## Public Input No. 11-NFPA 14-2013 [ Global Input ]

Include the provision of new design proposal in the code for Fire water system.

# TECHNICAL REPORT

FREEZING ISSUE IN THE PLANT OF FORT MCMURRAY, AB, CANADA

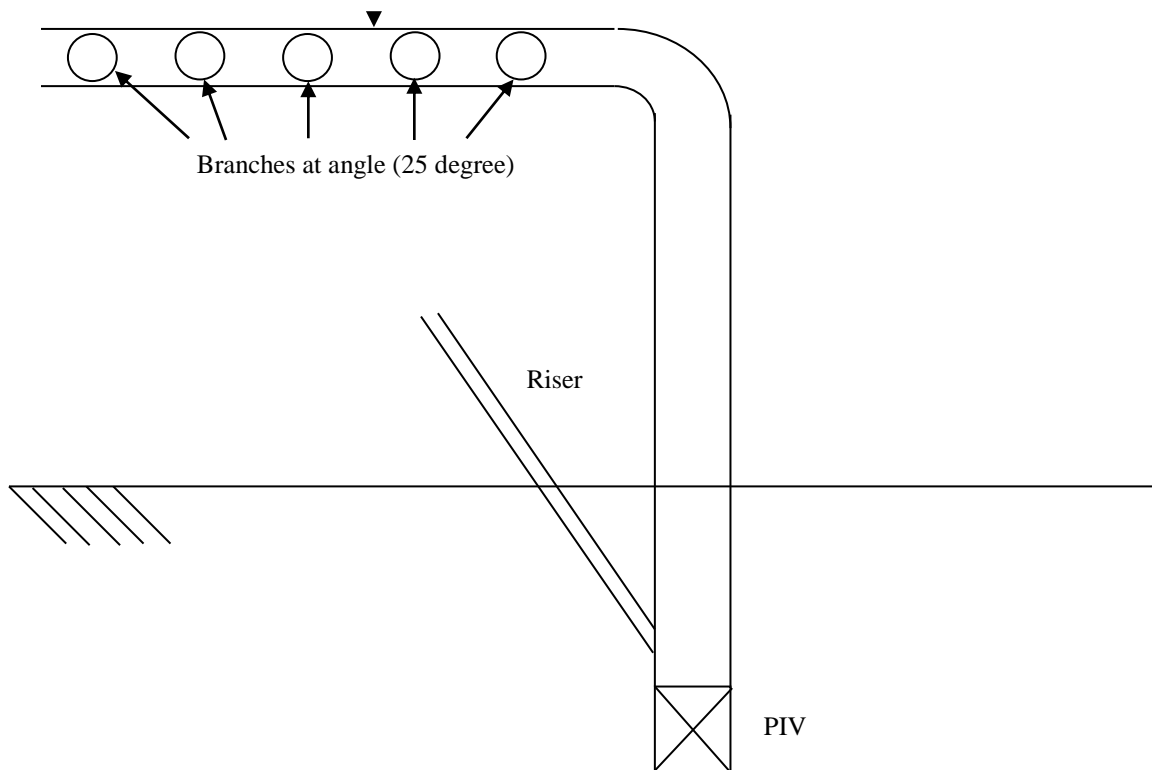
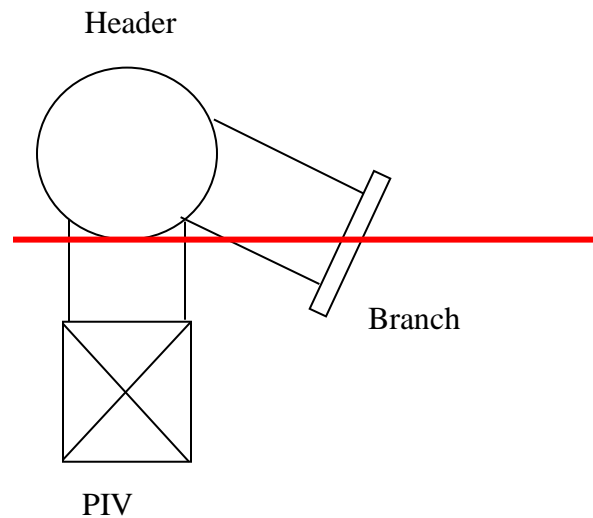
Freezing issue in the colder part of Canada and might solve the problem in other region. Please feel free to contact me or advise me to see personally to describe the proposal and solutions. This is the technical proposal in genral for all applicable NFPA codes as a preventive measure and could be include the last defense. Once the idea is approved, I can proceed for further action. I have this report to several authority but didn't get any feedback.

**10.3.7.2.1** To prevent freezing and corrosion, all low point drains in aboveground piping shall be opened, the pipe drained, and the valves closed and plugs replaced.

**10.3.7.2.2** Where weep holes are provided in lieu of low-point drains, they shall be inspected to ensure they are clear and unobstructed.

### **7.1: Application**

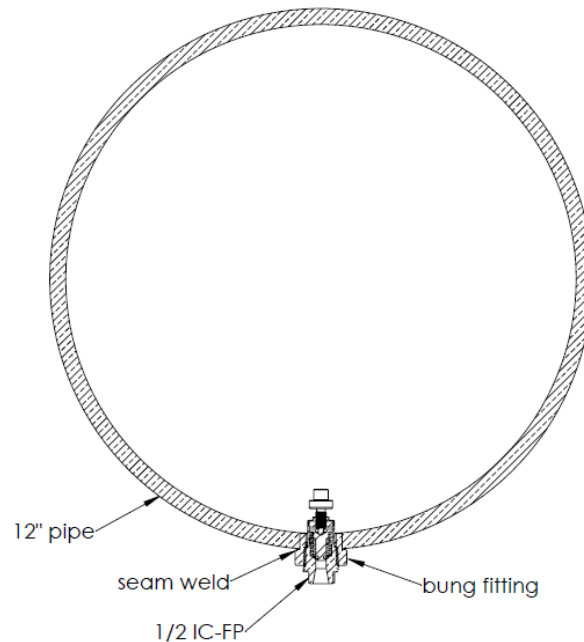
1/2" IC/FP (Freeze Protection) valves are ideal for the **protection of piping**, safety showers, solar collectors & piping, **condensate systems**, **fire lines**, spray nozzles, or **as backup protection on traced systems**. Its sensitivity to water temperature makes this valve ideal for applications where water conservation or wastewater disposal are a prime concern.

The 1/2" IC/FP will screw into any threaded opening with adequate internal clearance (see drawing at "Parts and Materials"). When the fluid temperature approaches freezing, and freeze damage is imminent, the thermal actuator modulates the valve open. When the makeup water temperature returns to the safe range, the valve then modulates closed, minimizing water loss. Due to the actuator's placement in the fluid stream, this valve is unaffected by ambient air temperature, and opens only when the water is in danger of freezing, being open at 35°F (1.7°C), and closed at 40°F (4.4°C)

**FIGURE A.7.3.2.2.1 Horizontal Exits**

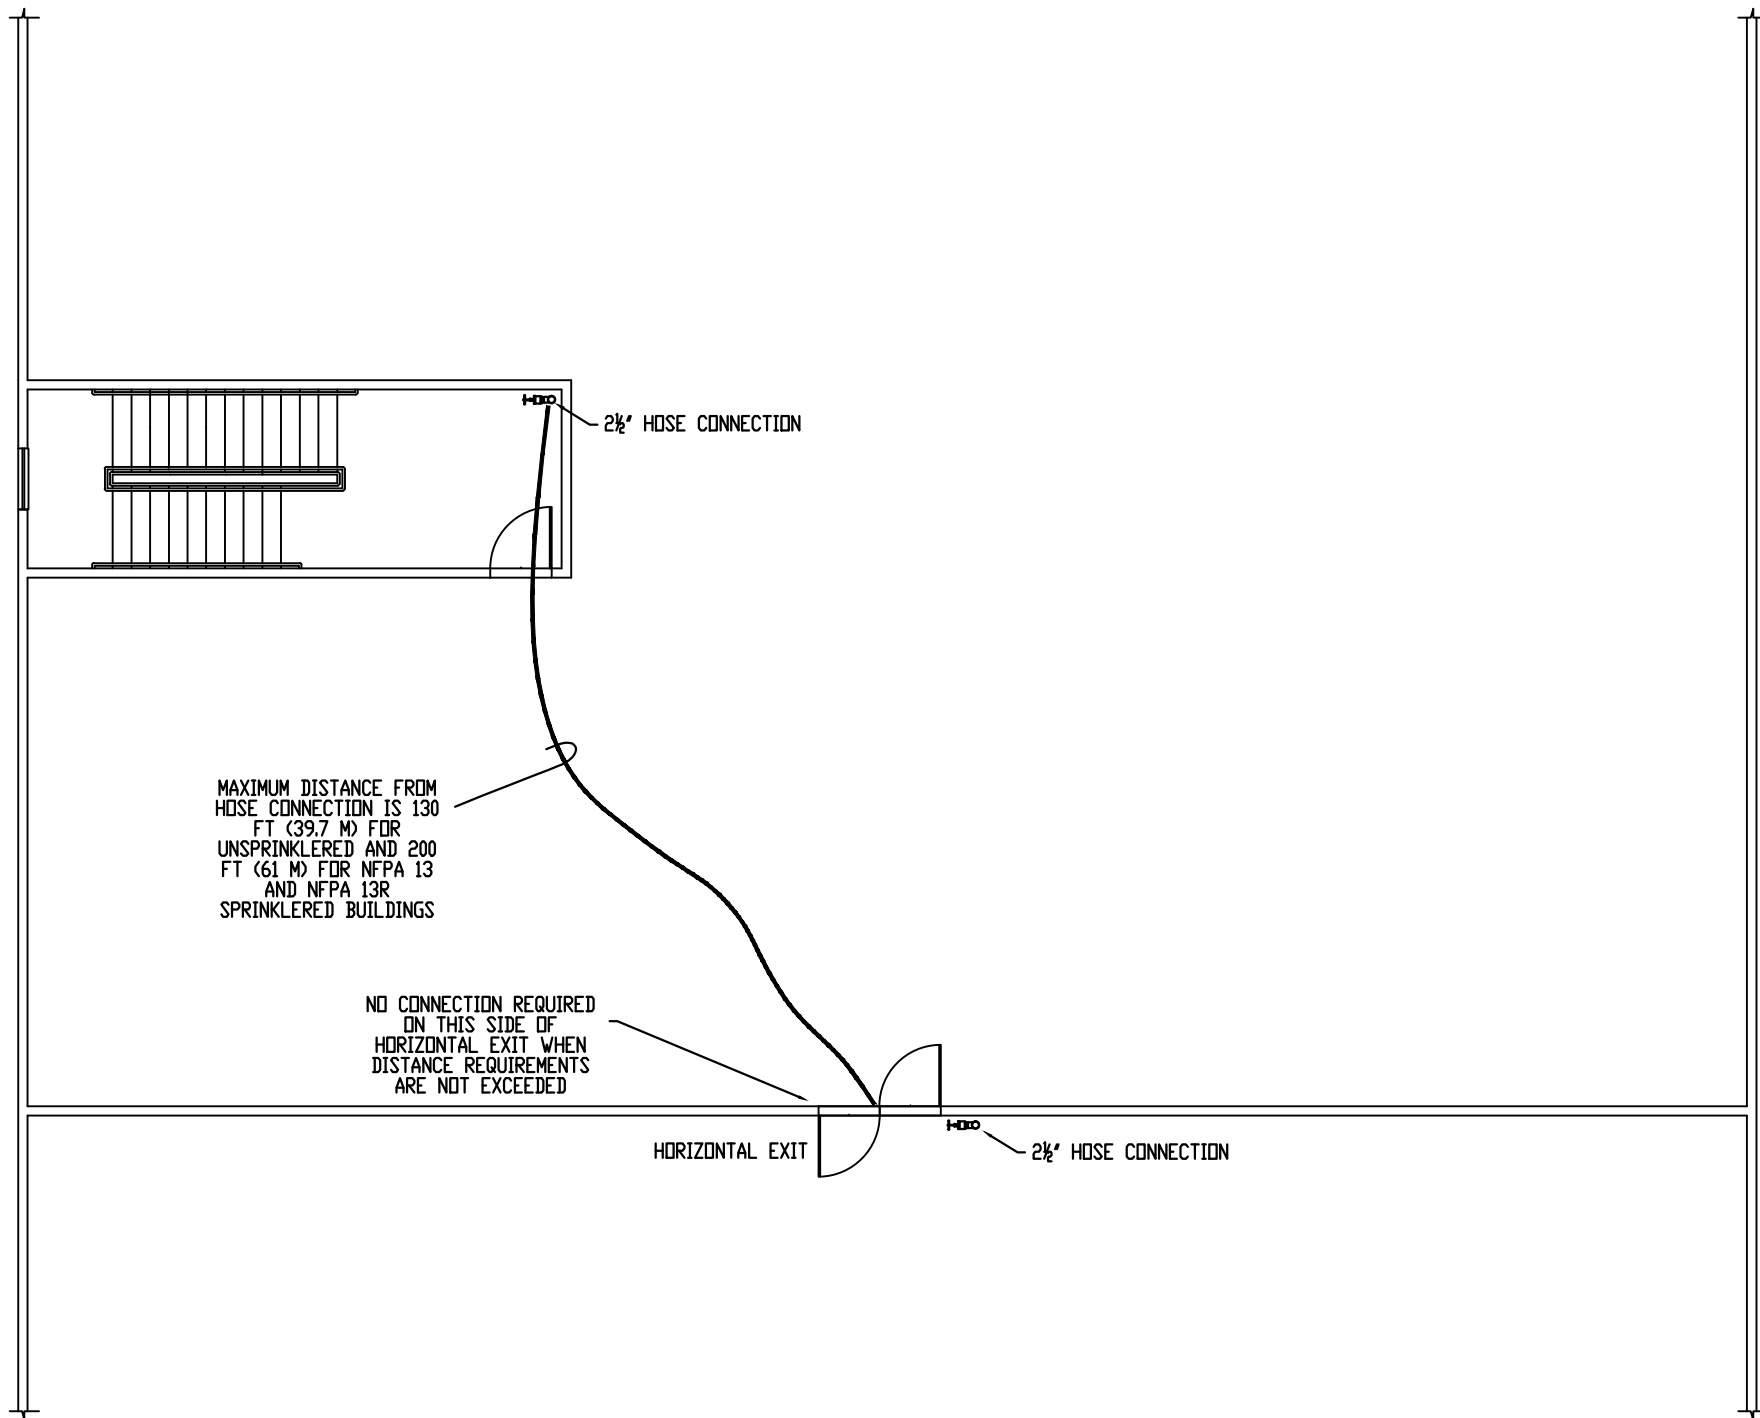
The most significant change was in regards to horizontal exits. In the ROP, there is a conflict between the adopted language of Proposal 14-48 and the wording on the annex Figure A.7.3.2.3. A new annex figure has been provided.

The most significant change was in regards to horizontal exits. In the ROP, there is a conflict between the adopted language of Proposal 14-48 and the wording on the annex Figure A.7.3.2.3. It is not clear as to which valve on which side of the horizontal exit can be eliminated. Does the travel distance have to extend completely through the horizontal exit and reach all areas on the opposite side of the horizontal exit? This language gives credit for sprinkler systems and eliminates connections at the horizontal exit provided that the 200 foot travel distance is met. This will be in conflict with the International Building Code at first but this is the installation standard. NFPA 14 should be dictating these requirements. The building code should only be dictating when standpipes are required, not locations of hose connections, etc. Since the building code borrowed the language from NFPA 14 in the first place, they should be synchronizing with NFPA at each code cycle revision. In addition, NFPA 14 as written in the ROP stage is in conflict already with the building code because of the allowance for 200' of travel distance. This committee is made up of experts on standpipes and writing these rules definitely falls within their purview. The exception for unsprinklered buildings (130 ft) will not appear in NFPA 14 as it does in the building code.

**A.7.3.2.2.1** See Figure A.7.3.2.2.1. (Rename Figure A.7.3.2.3 to A.7.3.2.2.1)
